Request #: HUTRR113  
Title: Additional Sensor Usages for Multi-Person Detection  
Spec Release: 1.4  
Requester: Sergii Liashenko  
Company: Microsoft

-----  
Current Status: **Approved**  
Priority: Normal  
-----

Add new Usages to the Sensors Page (0x20) to support Human Presence Detection sensors with Multi-Person Detection capability.

Head position parameters:

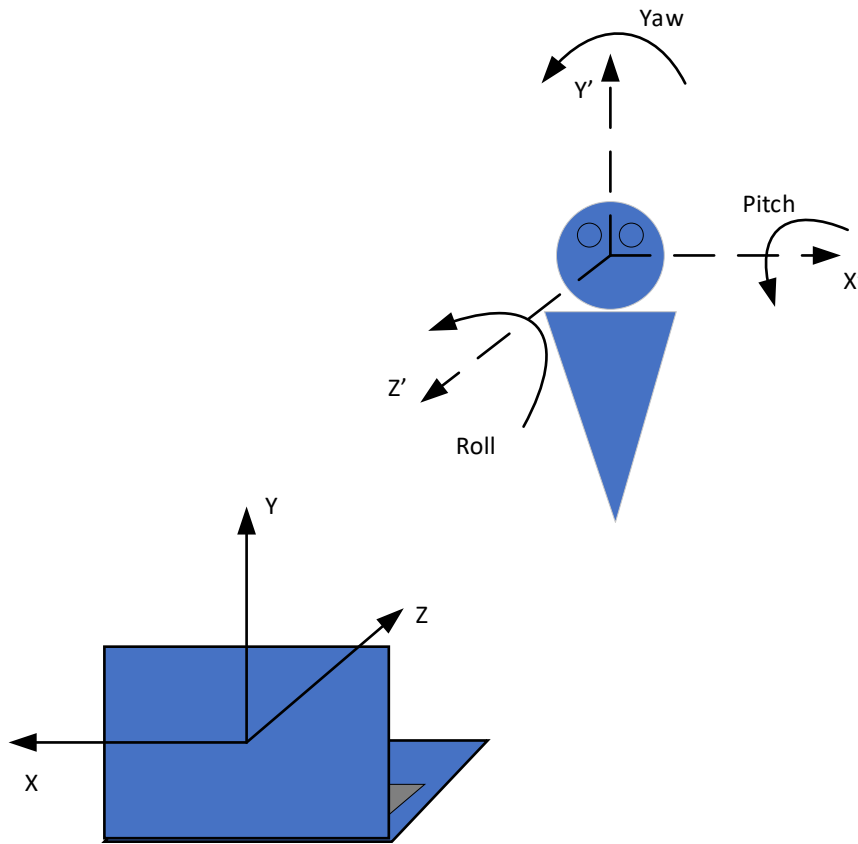
- The head position is specified as Azimuth and Altitude angles.
- Azimuth is the angle between Z axis and XZ-projection of the vector pointing from the device to the center of the person's face. Range  $[-90, 90]$ . The angle value is positive in the counterclockwise rotation around Y axis.

- Altitude is the angle between the vector pointing from the device to the center of the person's face and its XZ-projection. Range  $[-90, 90]$ . Positive values specify an angle toward the positive Y axis.

- Axes start at the center of the device's screen.
- The center of the person's face is considered a point between the eyes.
- The X axis is in the plane of the device's screen and is positive towards the right hand side of the screen from the perspective of a user facing the device.

- The Y axis is in the plane of the screen is positive towards the top of the screen.
- The Z is perpendicular to the screen, positive toward a user facing the device.

- Axes are fixed relative to the device and don't change with the device's rotation.
- For non screen-based devices the axes are defined relative to the devices' front panel.
